ADA Access Barrier Assessment Report For

**Pro Building
507 F Street
Eureka, CA 95501
Last Updated 8/14/2023**

Proposed Solution: Relocate outlet to area with min. 15" low reach or max. 48" high reach

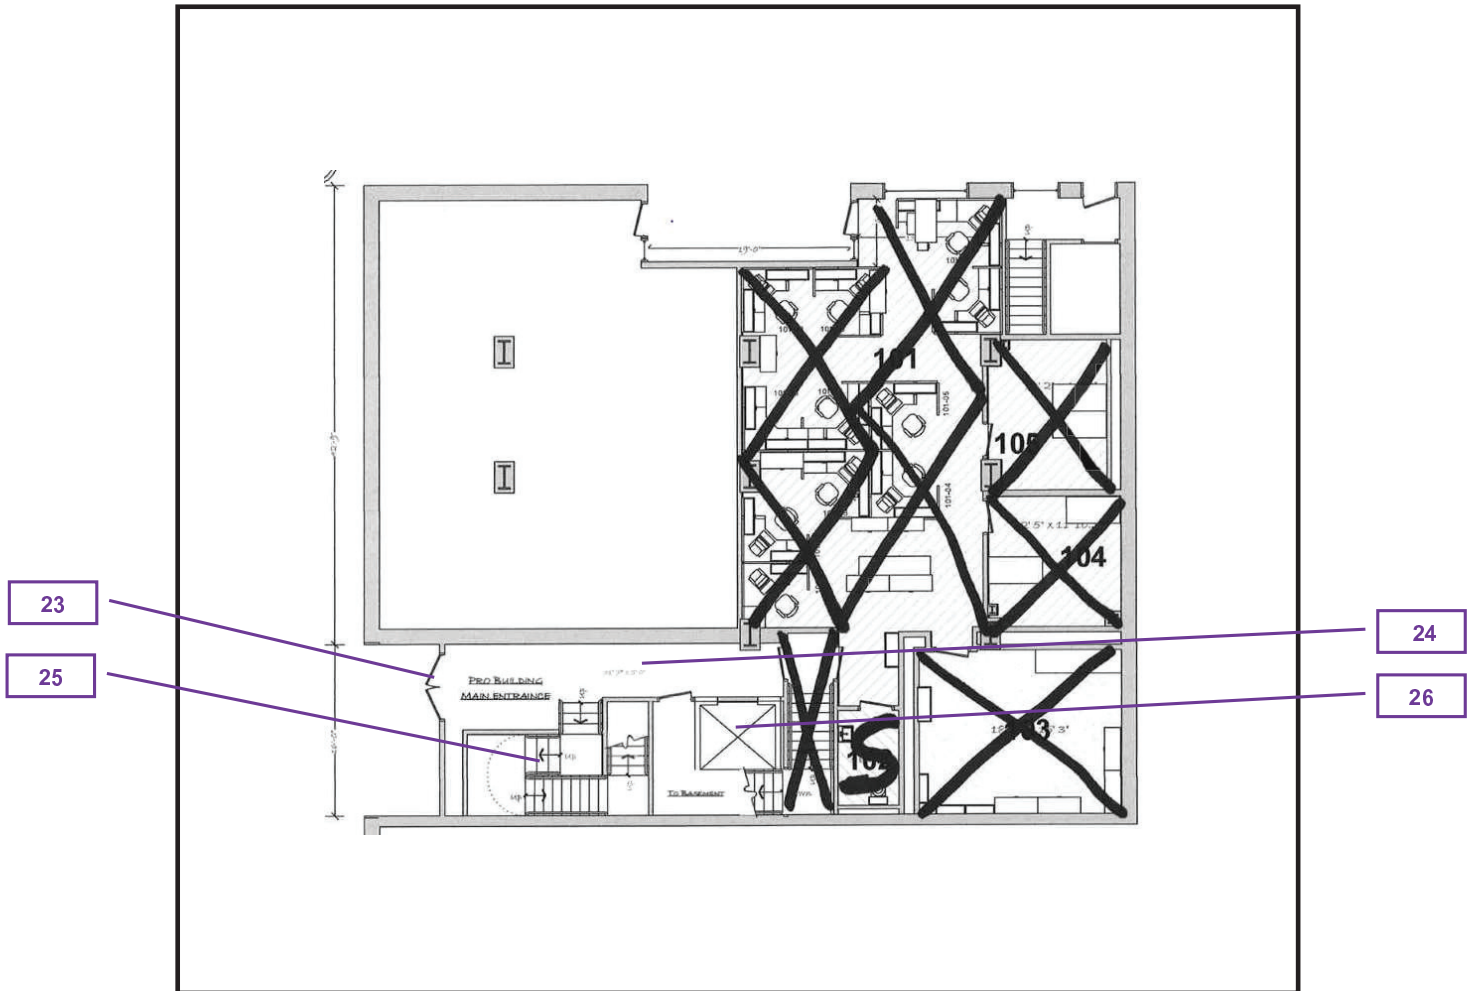
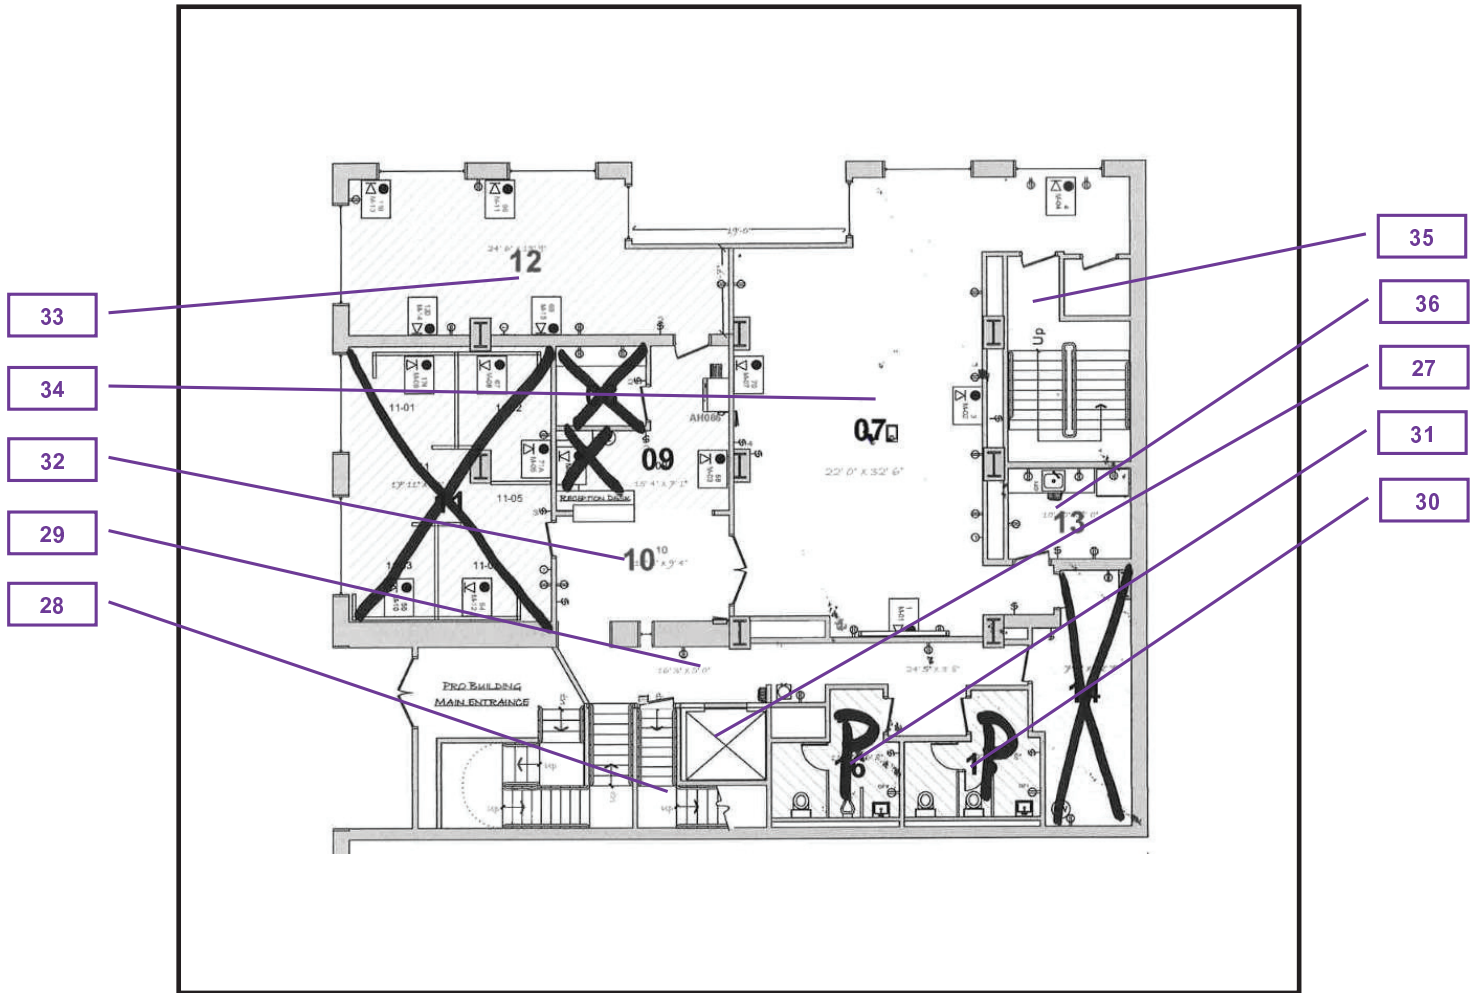
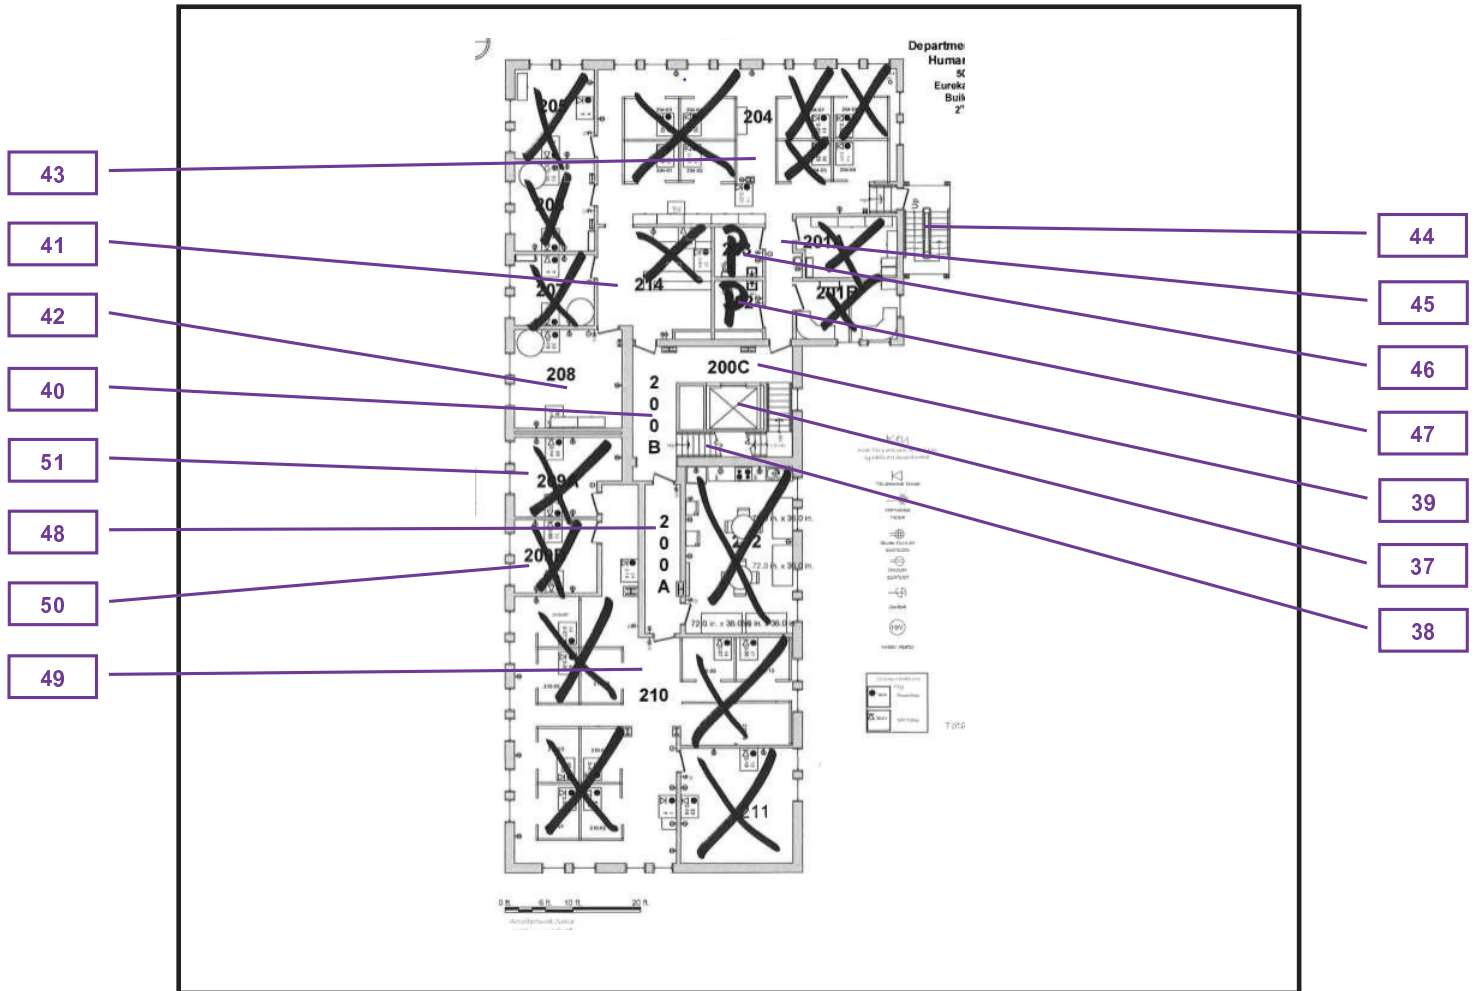
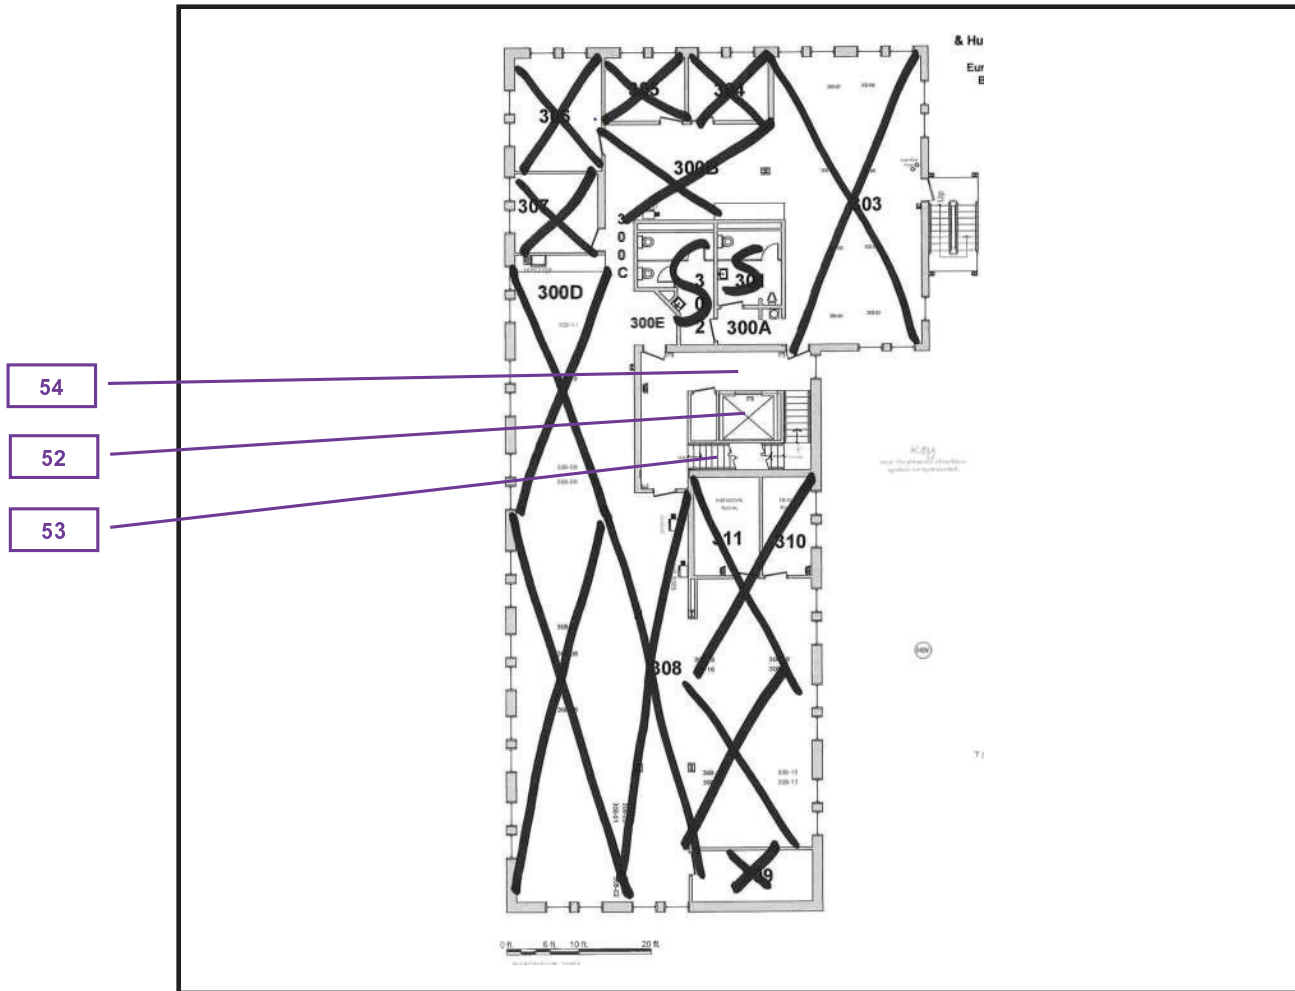
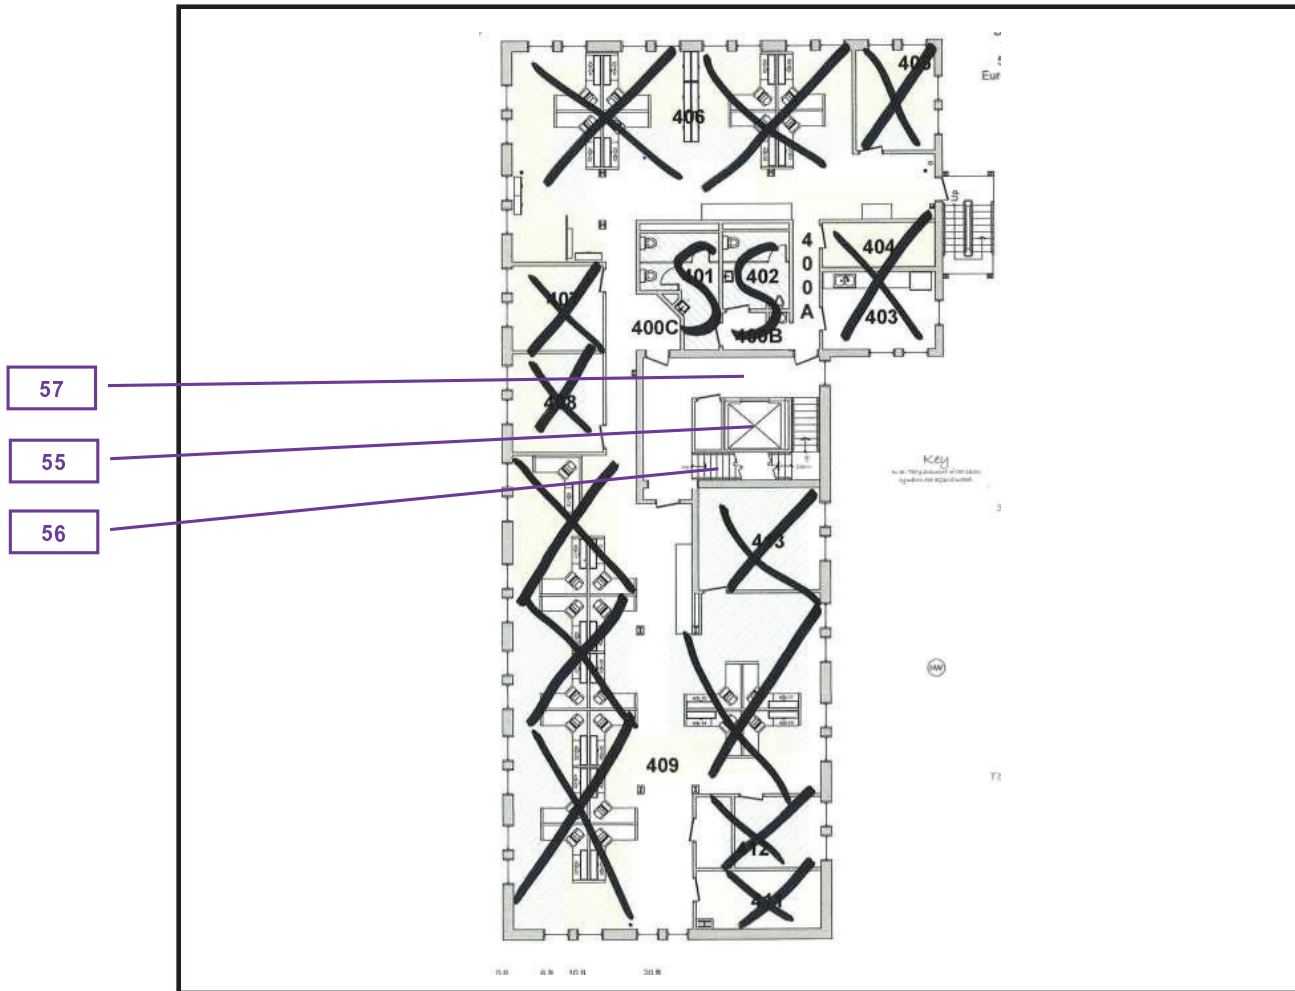
Code References: CBC 11B-306.3 and 2010 ADAS 306.3

As Built Description: Table clear floor space not provide for wheelchair users

Proposed Solution: Rearrange furniture to provide wheelchair access

szs 16A
2nd Floor Stairway
OPEN

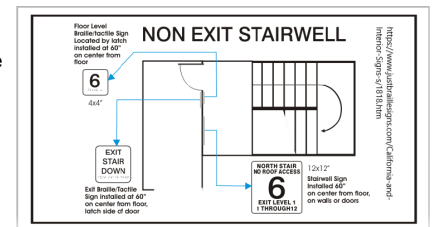
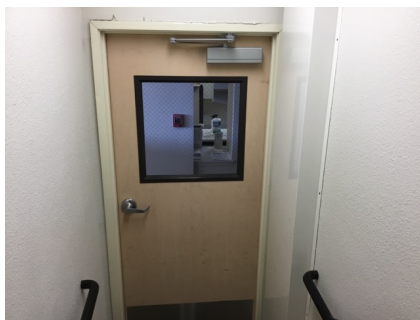
Stairway identification signs serving also as a floor identification sign does not provide compliant raised characters and braille on the sign to identify the floor level.

Two signs are required for enclosed stairways: Stairway Identification Sign (provided but does not require tactile characters and braille. characters should be removed or corrected) at each floor landing in an interior exit stairway connecting more than three stories designating the floor level, the terminus of the top and bottom of the interior exit stairway and ramp and the identification of the stairway. The signage shall state the story of, and the direction to, the exit discharge and the availability of roof access from the interior exit stairway for the fire department. The sign shall be located 5 feet above the floor landing in a position that is readily visible when the doors are in the open and closed positions. Additionally: Floor identification signs required by Chapter 10, Section 1023.9 complying with Sections 11B-703.1, 11B-703.2, 11B-703.3 and 11B-703.5 shall be located at the landing of each floor level, placed adjacent to the door on the latch side, in all enclosed stairways in buildings two or more stories in height to identify the floor level. At the exit discharge level, the sign shall include a raised five pointed star located to the left of the identifying floor level. The outside diameter of the star shall be the same as the

SZS 31B
3rd Floor Staiway
OPEN

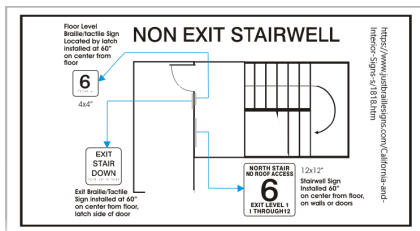
Stairway identification signs serving also as a floor identification sign does not provide compliant raised characters and braille on the sign to identify the floor level.

Either remove braille or replace with compliant braille on stairway signs. Also provide compliant floor identification signs on the latch side of doors within the enclosed stairway and exit signs at stairway entries where illuminated signs are also provided. (Also see item 16A).

SZS 31C
3rd Floor Staiway
OPEN

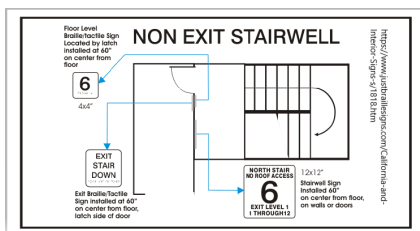
Stairway identification signs serving also as a floor identification sign does not provide compliant raised characters and braille on the sign to identify the floor level.

Either remove braille or replace with compliant braille on stairway signs. Also provide compliant floor identification signs on the latch side of doors within the enclosed stairway and exit signs at stairway entries where illuminated signs are also provided. (Also see item 16A).

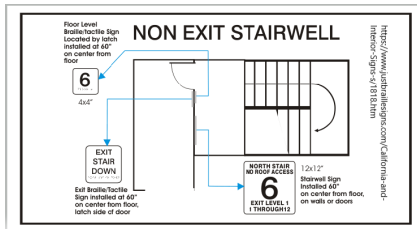
Stairway identification signs serving also as a floor identification sign does not provide compliant raised characters and braille on the sign to identify the floor level.

Stairway identification sign mounted 59.75", and braille is recessed at sign not requiring tactile characters.

Either remove braille or replace with compliant braille on stairway signs. Also provide compliant floor identification signs on the latch side of doors within the enclosed stairway and exit signs at stairway entries where illuminated signs are also provided. (Also see item 16A).

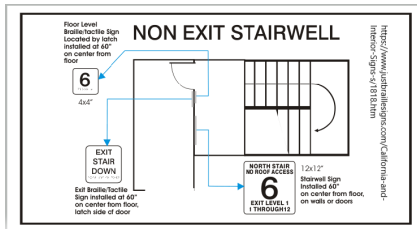
Stairway identification signs serving also as a floor identification sign does not provide compliant raised characters and braille on the sign to identify the floor level.

Stairway identification sign removed. (May be required for fire & life safety).

Provide stairway identification sign as needed. Also provide compliant floor identification signs on the latch side of doors within the enclosed stairway and exit signs at stairway entries where illuminated signs are also provided. (Also see item 16A).

SZS 42P
Women's Restroom
OPEN

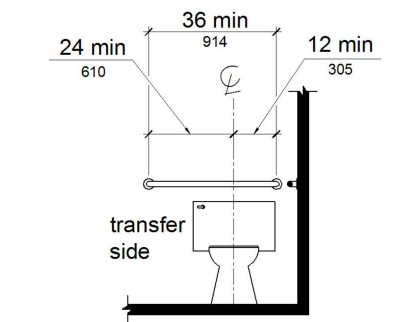
ADA 2010: 604.5.2

CBC 2019: 11B-604.5.2

SZS 19F
Second Floor – Lobby 214
OPEN

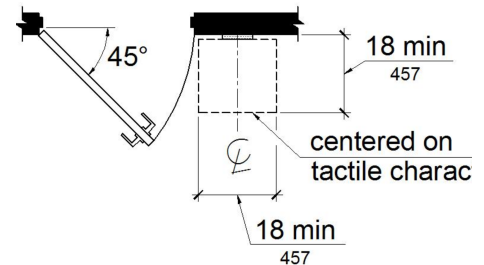
ADA 2010: 703.4.2

CBC 2019: 11B-703.4.2
